GW - 258

INSPECTIONS & DATA

BURLINGTON
RESOURCES

RE: Burlington Resources Compressor Station Site Inspections 2000. **Manzanares GW-05, Gobernador GW-056, Pump Mesa GW-148, Quinn GW-239, Sandstone GW-193, Rattlesnake GW-093, Buena Vista GW-255, Pump Canyon GW-057, Hart Canyon GW-058, Cedar Hill GW-258, and Middle Mesa GW-07:**

Picture #2- Plant ESD and normal vent stack located east of plant.

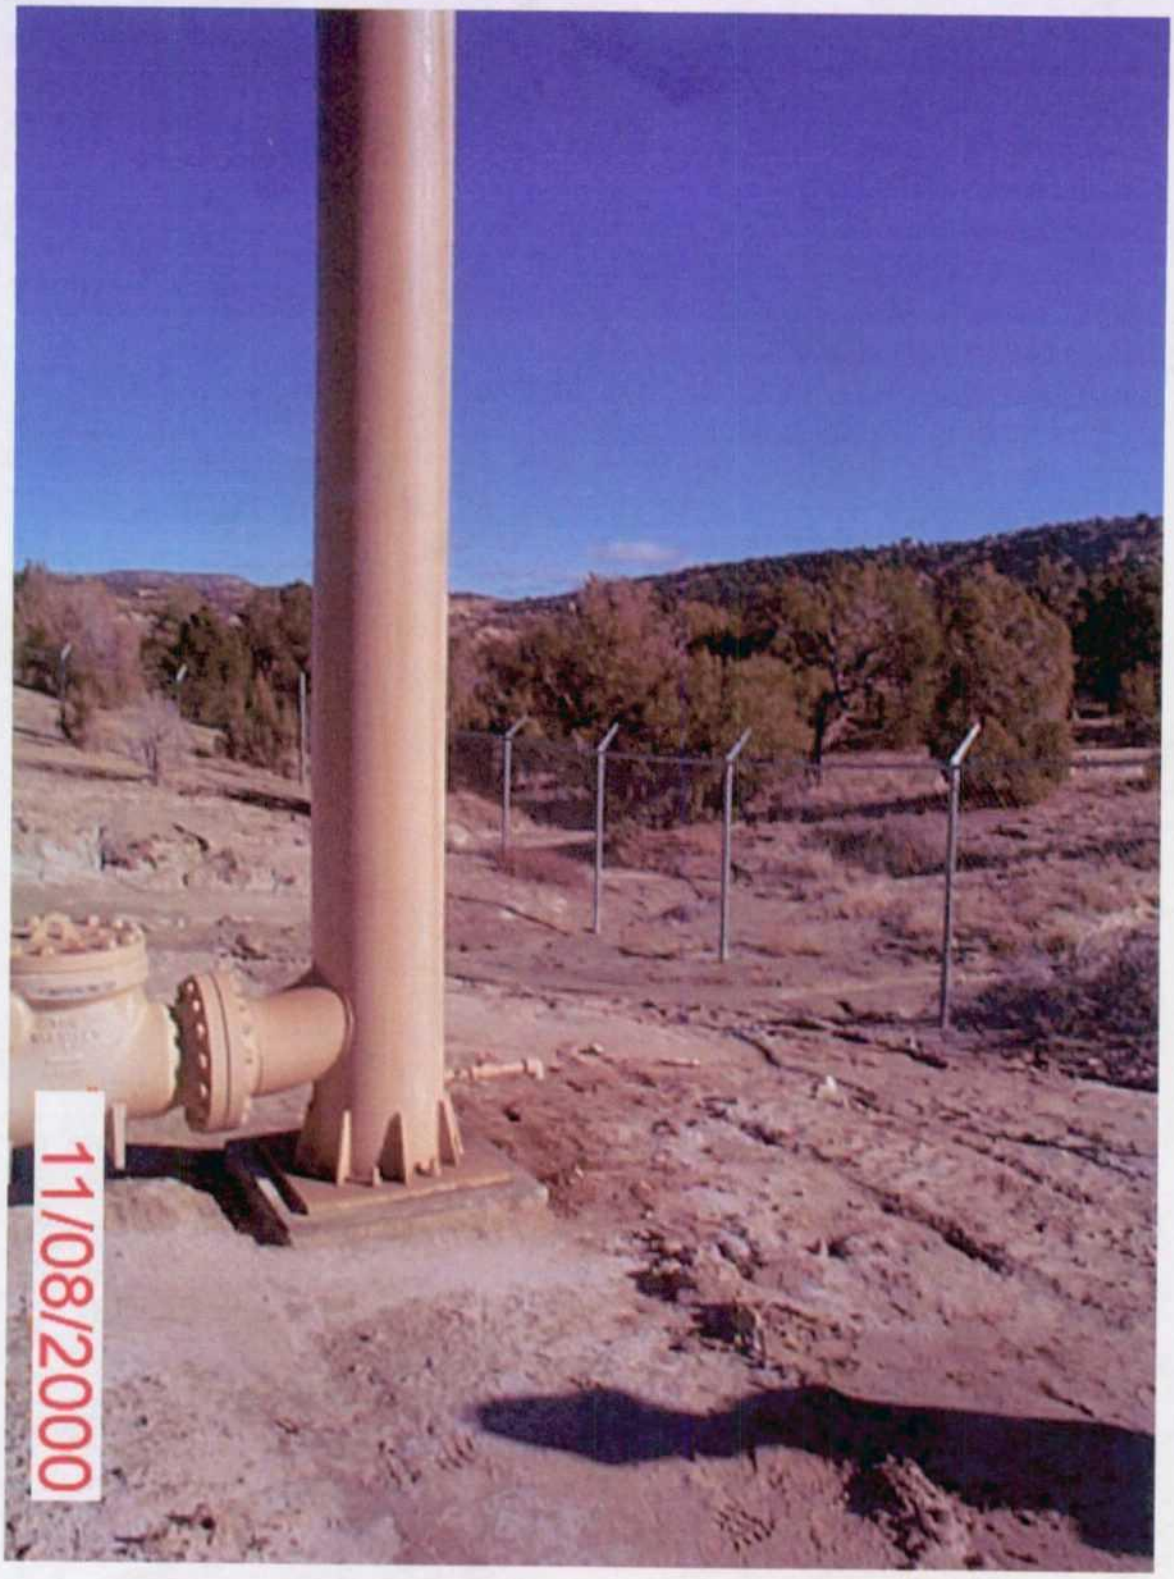
Plant main vent system has oil accumulating on stack and system is located in stormwater drain area. ***The staining was caused by hydrocarbons and water that have accumulated in the Emergency Shut Down stack between shutdowns. Shut downs are infrequent and only in an emergency. The oil staining was observed to be insignificant and unlikely to contribute to a reportable storm water release. However, the soil was cleaned and will be monitored for future stack accumulations and any resulting soil staining will be remediated.***

1. Plant main vent system has oil accumulating on stack and system is located in stormwater drain area. (see picture #2)

2. Process Areas: All process and maintenance areas which show evidence that leaks and spills are reaching the ground surface must be either paved and curbed or have some type of spill collection device incorporated into the design.
ESD VENT - MOUNTED IN ARROYO - NEEDS PROPER CONTAINMENT/CONTROL TO SATISFY STORMWATER PLAN - VISUAL OIL ON STACK
PIC # 2
